**Project: IEEE P802.15 Study Group for Wireless Personal Area Networks (WPANs)**

**Submission Title:** PSSS proposal – Parallel reuse of 2.4 GHz PHY for the sub-1-GHz bands

**Date Submitted:** 17th May 2005

**Re:** PSSS mode for more even chiprates, simpler filter, and 250 kbit/s in 868 MHz and new less complex preamble.

## Comparision Actual/New Proposed Preamble Length of Proposed Preamble

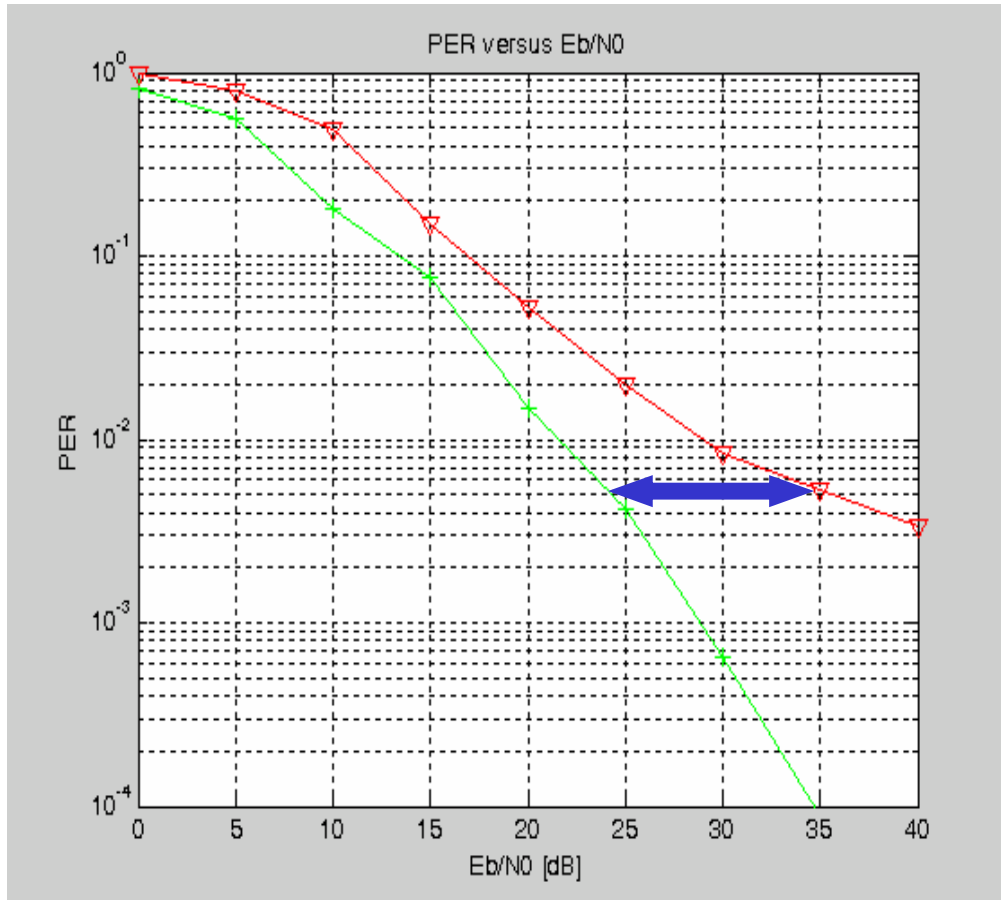
Barker Code	Sequence 0
DC free	yes	yes
32 Chip long	no	yes
# of needed FIR in Rx	2	1

- The Sequence 0 is repeated 4/16 times for 868/915 MHz. Same duration of 320 $\mu$ s for both preambles.

- We propose to use PSSS 250-400 instead of PSSS 206-440 for ETSI.
- We propose also to use the new preamble base on Sequence  $C_0$  for similar design compared to the other Phys.

# PSD for PSSS 250-400 868 MHz (in 600 KHz channel) Baseband pulse shaping non-linear “Real World PA”

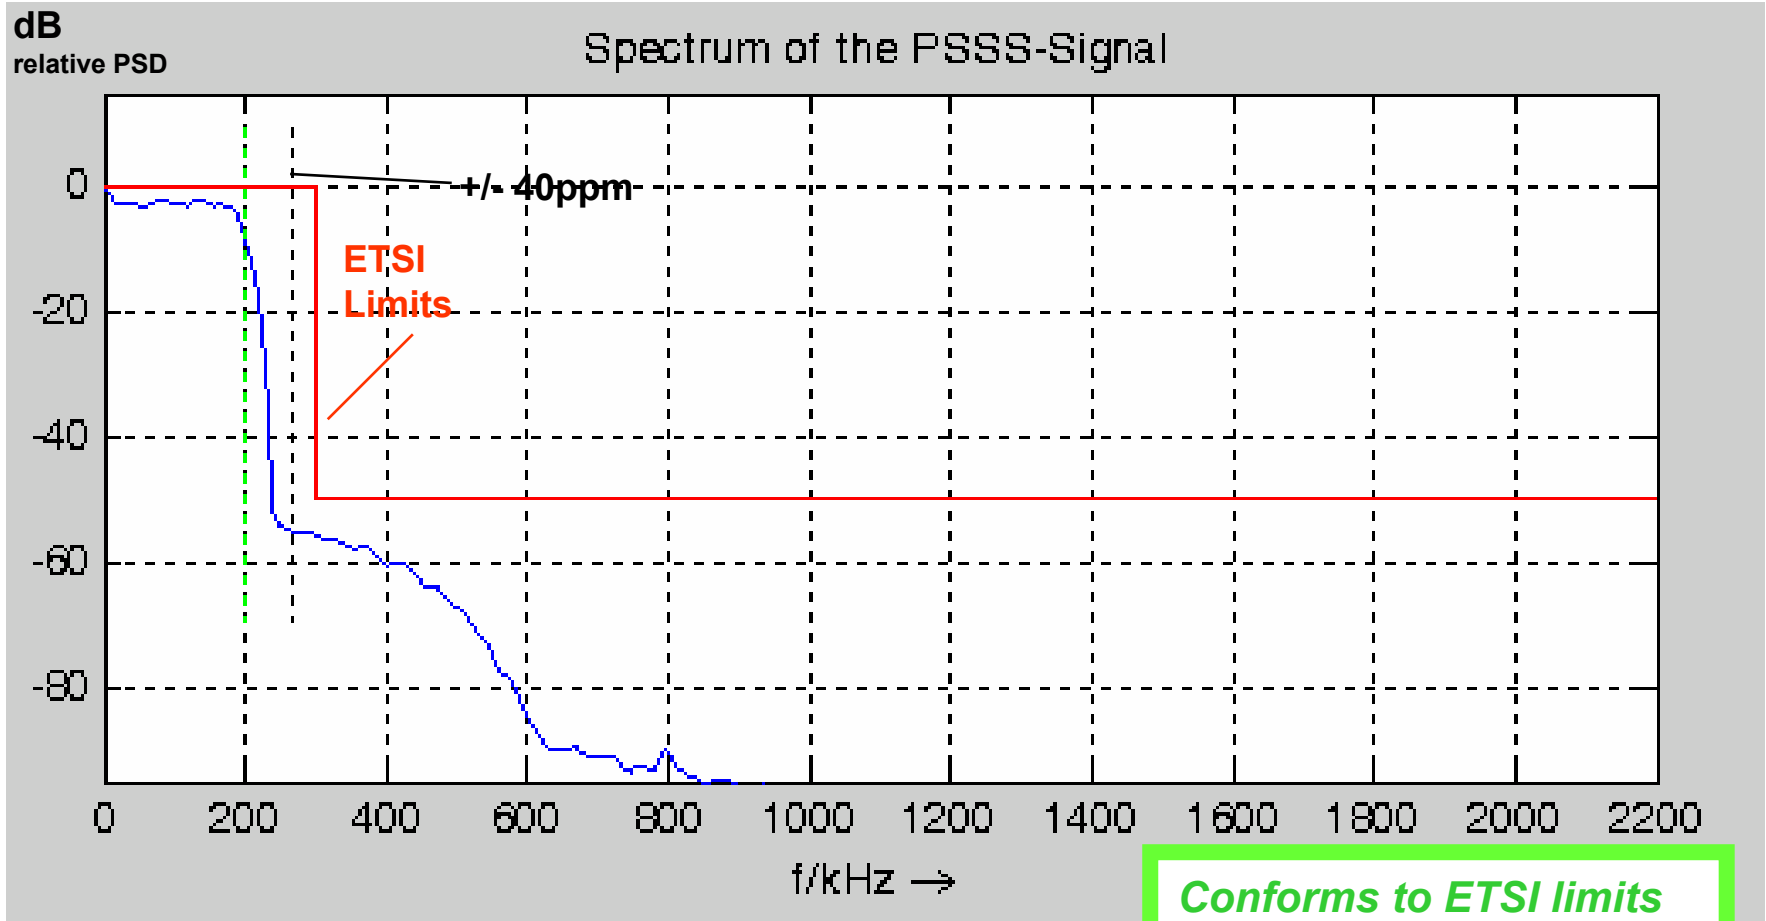
Simulations of the relative PSD in dB for the PSSS 250-400 signal: With precoding, at 400 kchip/s, 250 kbit/s, +/- 40ppm, 50% PA drive, square root raised cosine filter with  $r = 0.2$

# Preamble Detection with current Barker Code

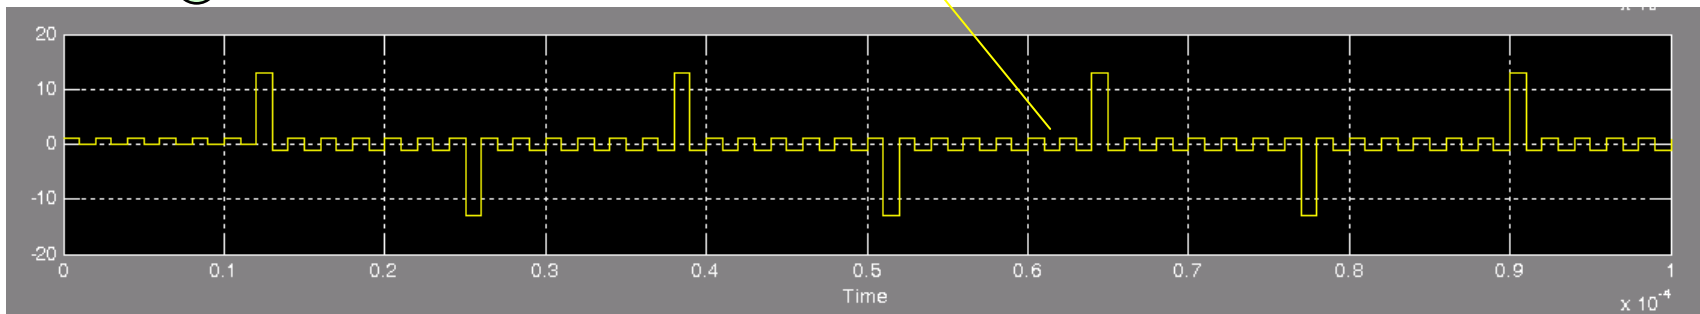
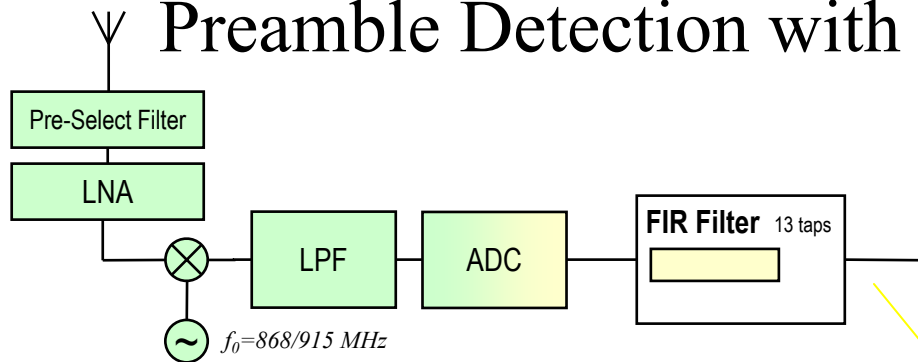
- When detecting the current barker code based preamble with FIR filter, the signal coming out of the FIR filter has side slopes limited to +/- 1.
- Advantages:
  - DC free
- Disadvantages:
  - **Two FIR filters needed**, one for preamble detection (13 chip barker code), one for PSSS decoding (31 chip m-sequence).
  - **Not multiple of symbol duration**

# Preamble Detection with Sequence 0 of the PSSS Coding Table as preamble

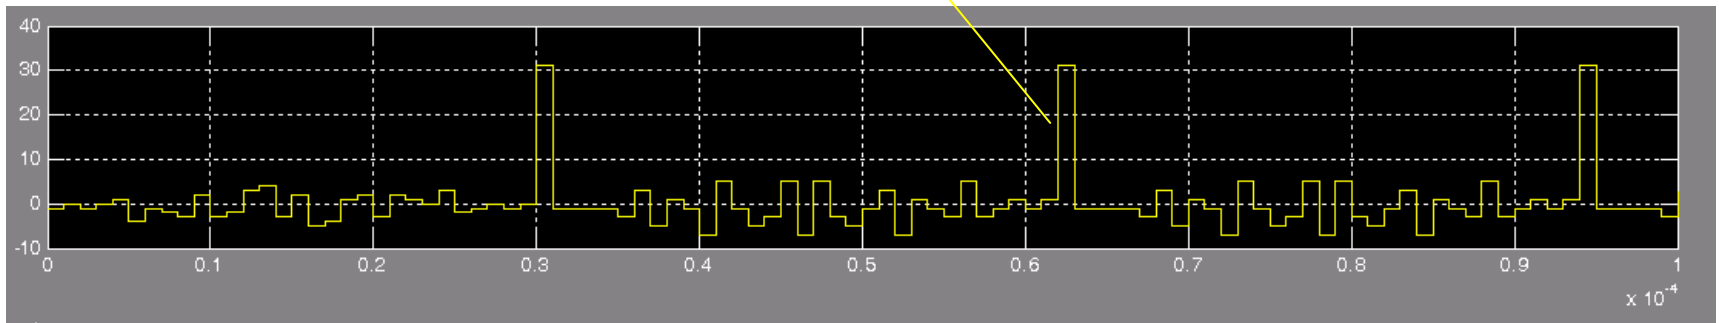
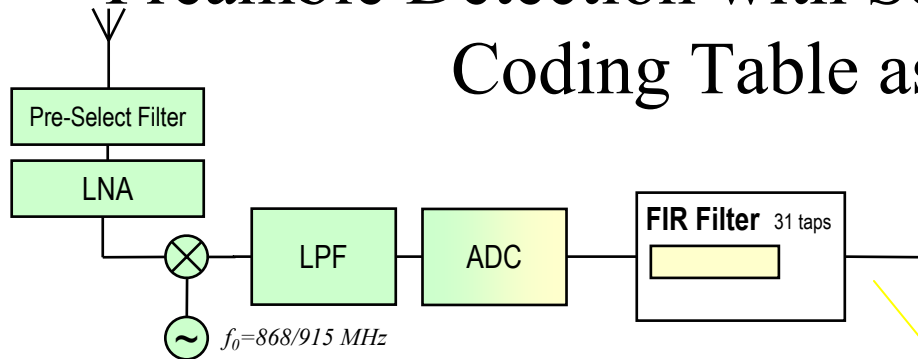
- When detecting the preamble, based on repeated sequence 0 with FIR filter, the signal coming out of the FIR filter has side slopes limited to +5/-6.
- Advantages:
  - Use of just one FIR filter or correlator for preamble detection and PSSS decoding.
  - **32 chip long preamble code.= multiple of symbol duration and similar to other phys.**
  - DC free
